# CITY OF SAN ANTONIO

## CAPITAL IMPROVEMENTS MANAGEMENT SERVICES (CIMS DEPARTMENT) PROJECT: SEELING CHANNEL IMPROVEMENTS - PHASE I

### ADDENDUM NO. 1

**DATE: August 16, 2012**

LANDSCAPE MATERIALS SCHEDULE

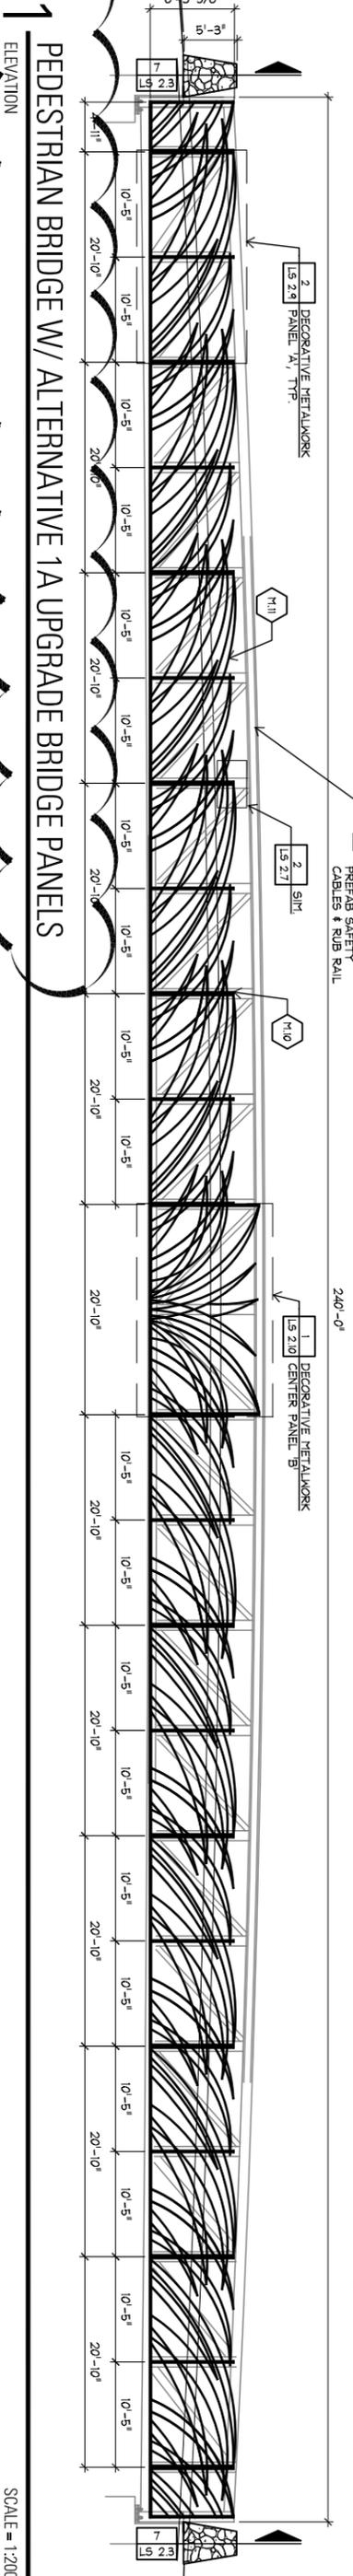
- 375 (LC 1.0) Landscape Materials Schedule
- 410 (LS 2.9) Sitework Details
- 411 (LS 2.10) Sitework Details

8/14/12	REVISED QUANTITIES		
NO	DATE	DESCRIPTION REVISIONS	DWGCHK
